Re: In Re: Application of Pennsylvania-American Water Company for approval of the right to offer, render, furnish or supply wastewater service in an additional portion of Elk Township, Clarion County, Pennsylvania. Docket No. A-2018-3006085

Bureau of Technical Utility Services
Water/Wastewater Division
Data Request Set 1

Application of Pennsylvania-American Water Company for approval of the right to offer, render, furnish or supply wastewater service to the public in an additional portion of Elk Township, Clarion County at Docket No. A-2018-3006085

Response A-6

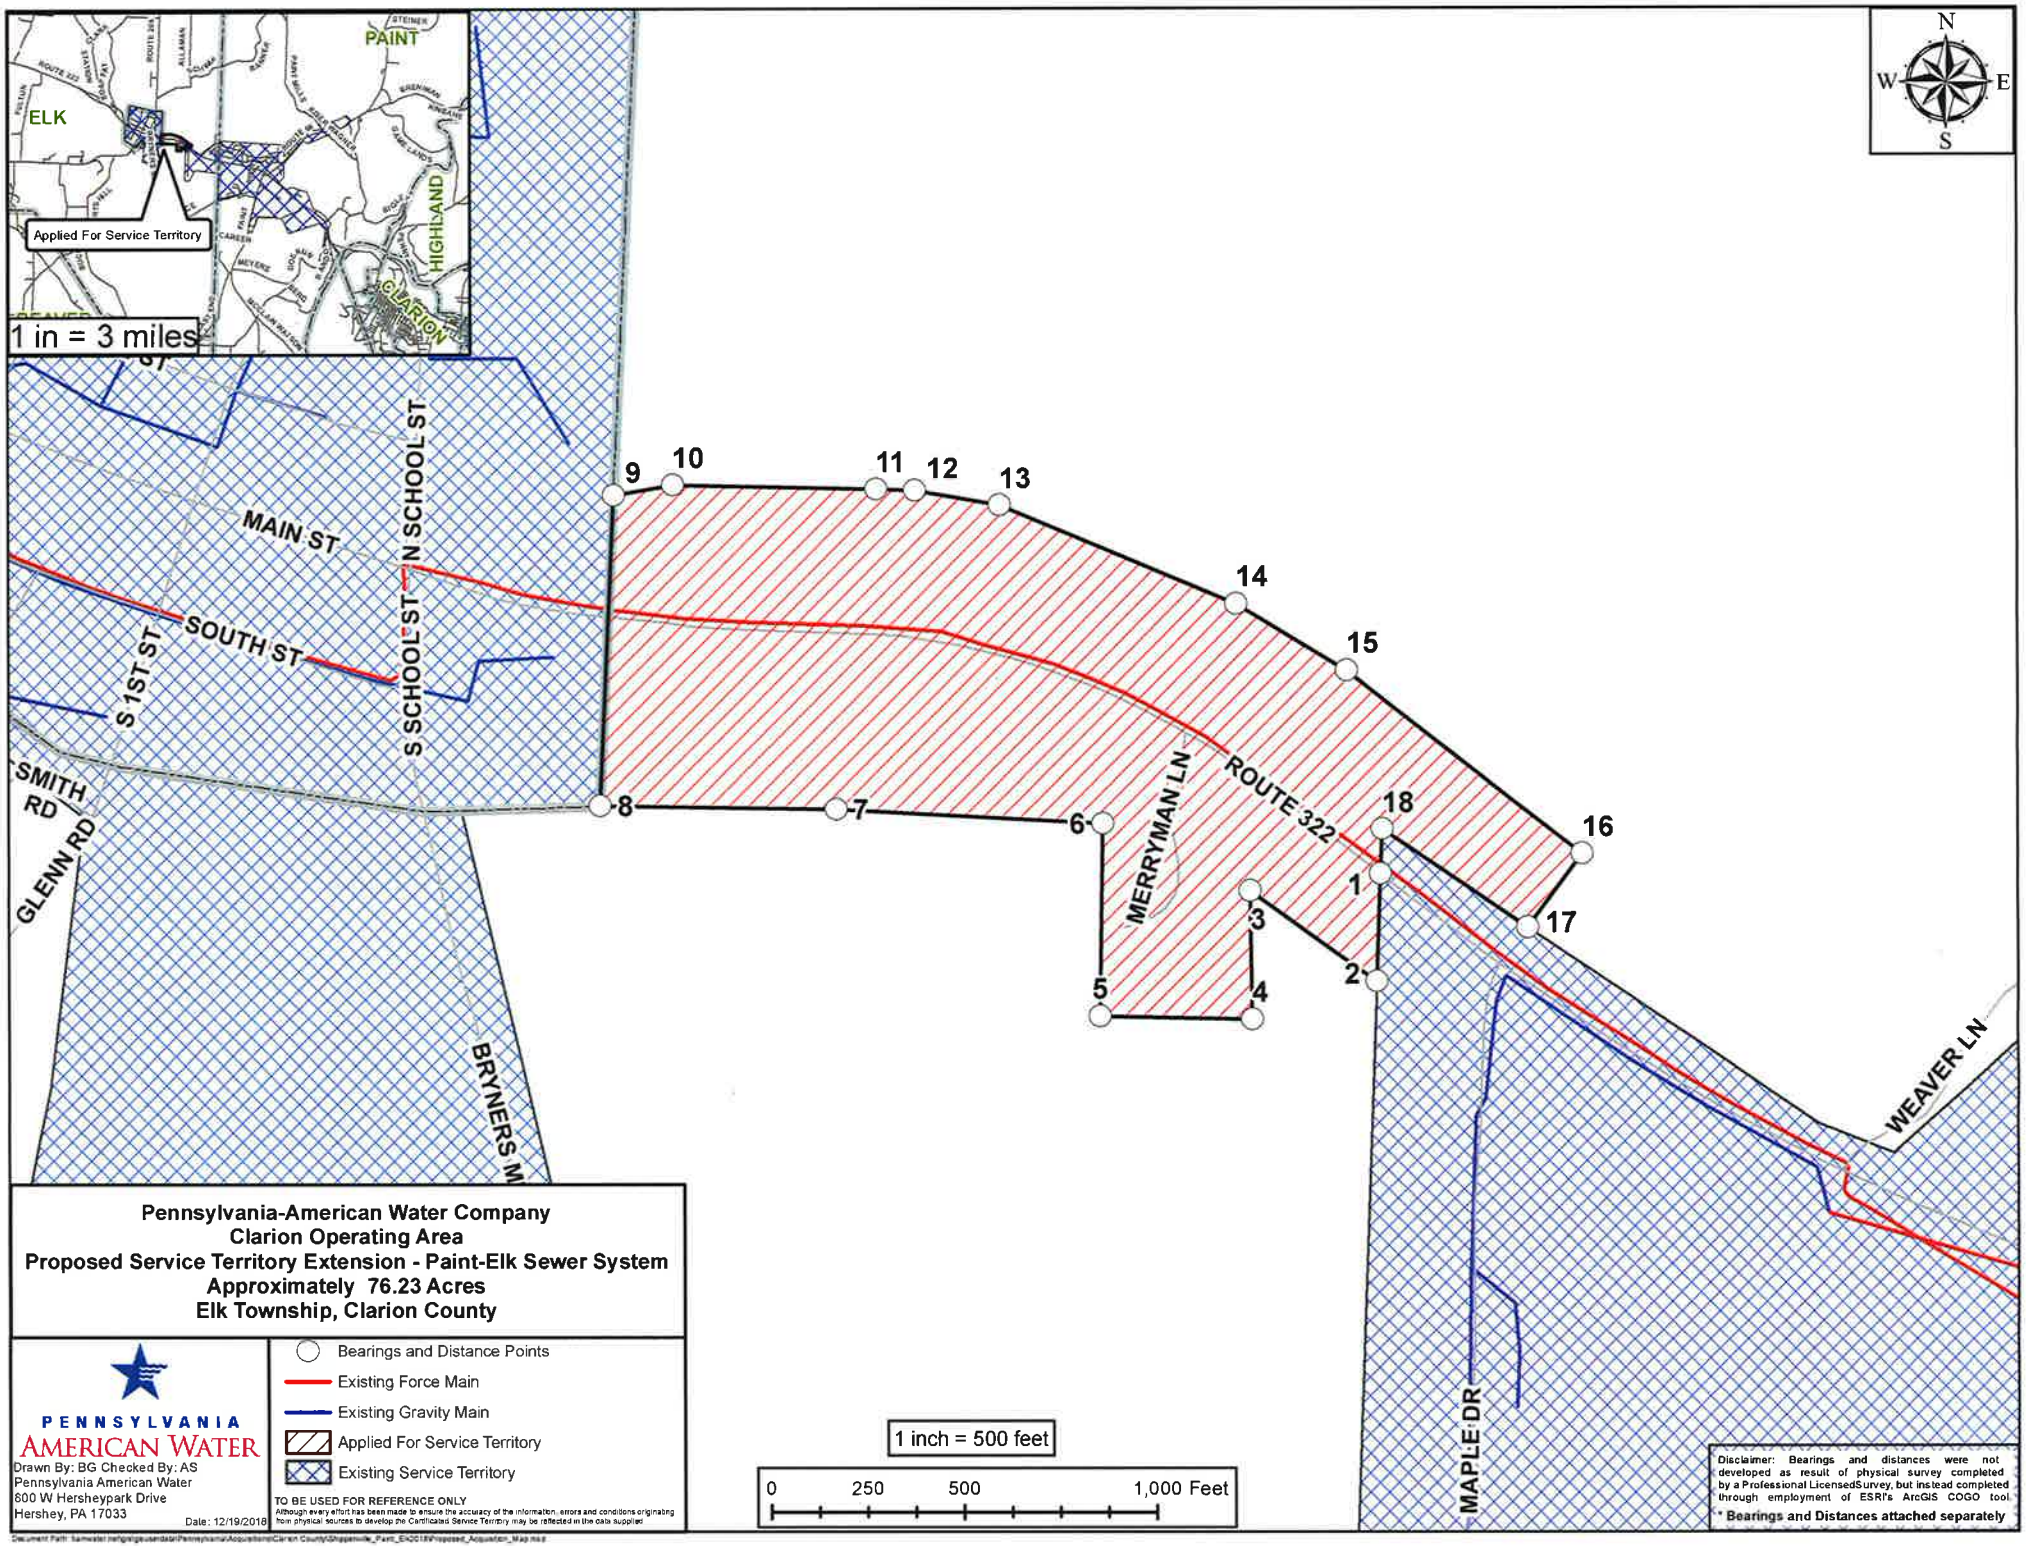
A-6. The Application's Exhibit B-1 contains an "existing service territory" depiction west of the requested territory that does not appear to match the certificated service territory granted at Docket No. A-2014-2441953. Specifically, the existing certificated service territory depiction appears to exclude a contiguous area south of Shippenville Borough along Bryners Road. Please revise the exhibit accordingly or confirm that PAWC-WD is also proposing to abandon certificated service territory.

Response: **Please see the attached updated map. PAWC is not proposing to abandon certificated service territory.**

FIGURE 2
USGS Quandrangle
Fryburg and Clarion

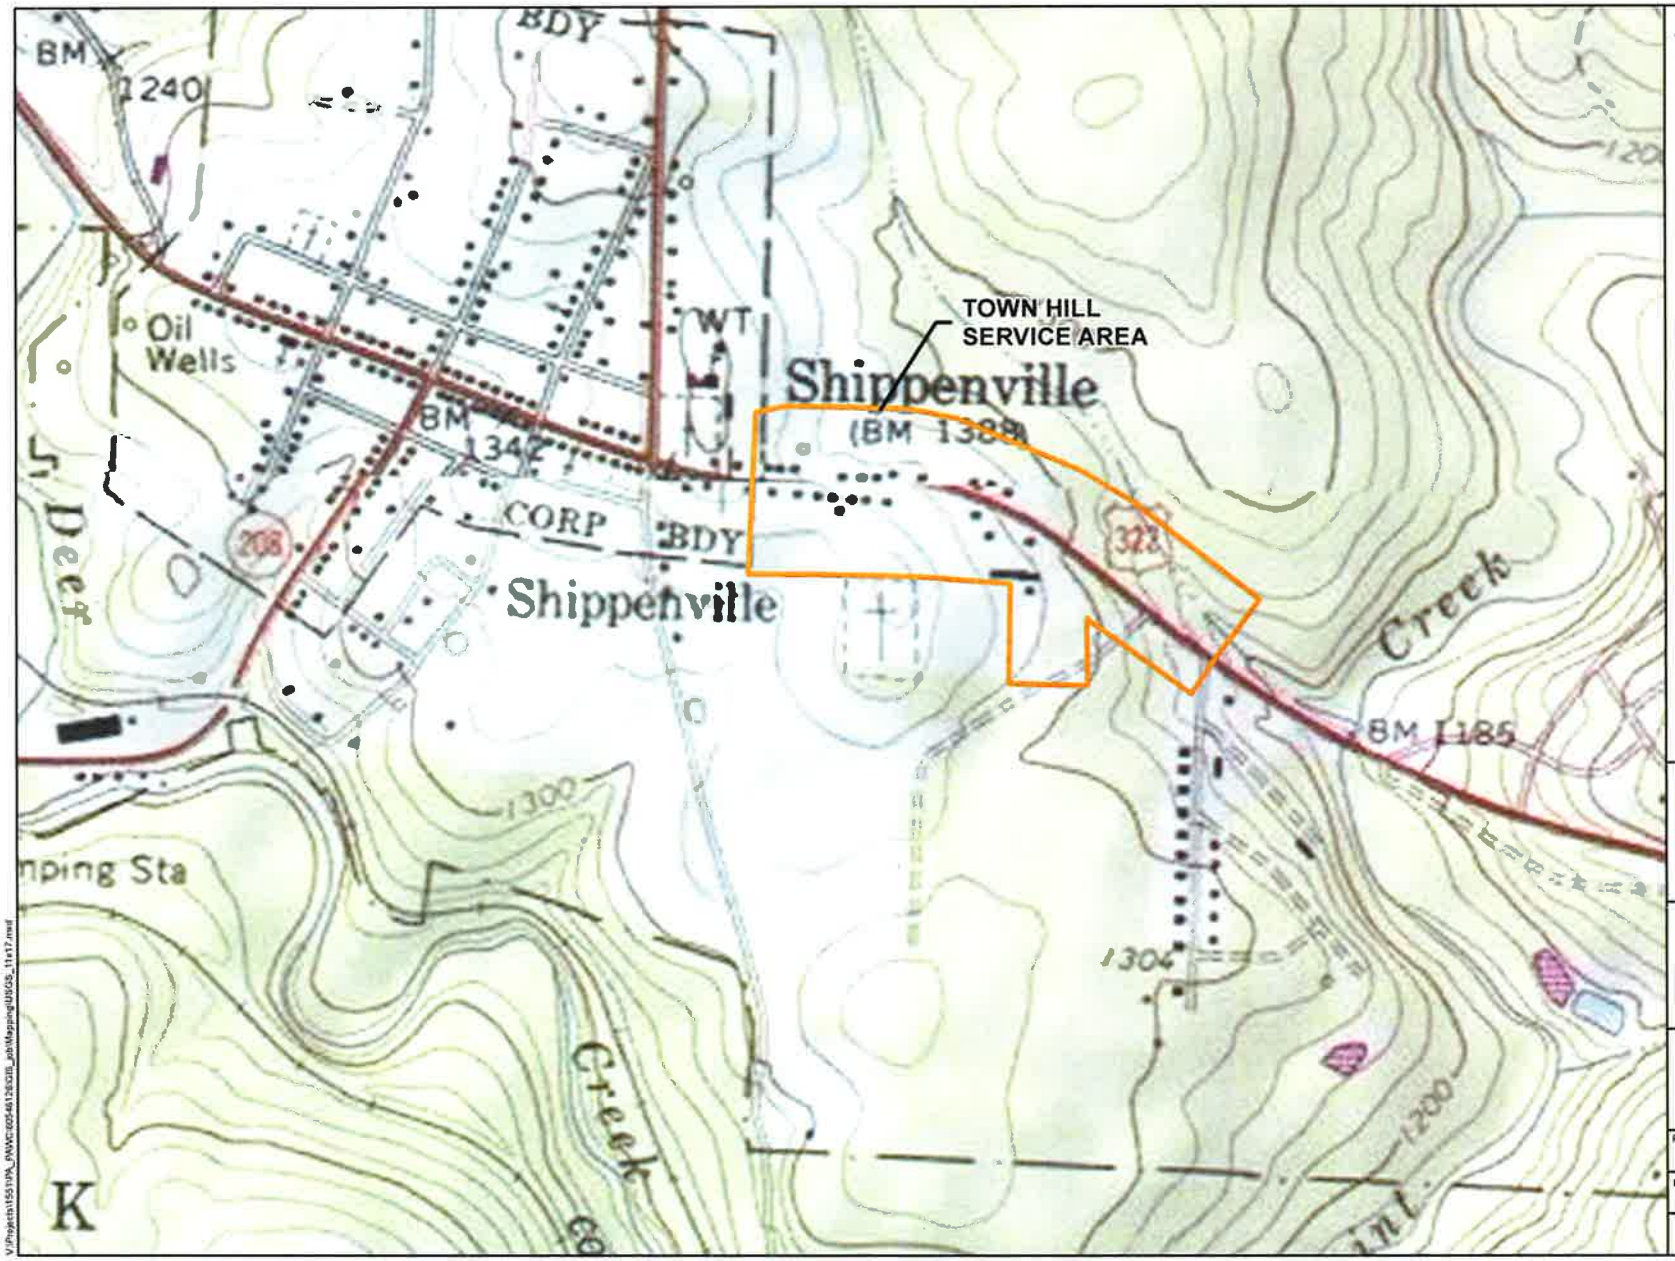
A-8. The Application's Exhibit J contains a table of contents that identifies Figures 1 and 2 that were not provided as part of the filing. Please provide a copy of these documents.

Response: **Please see the attached Figures 1 and 2 that were not provided as part of the filing.**
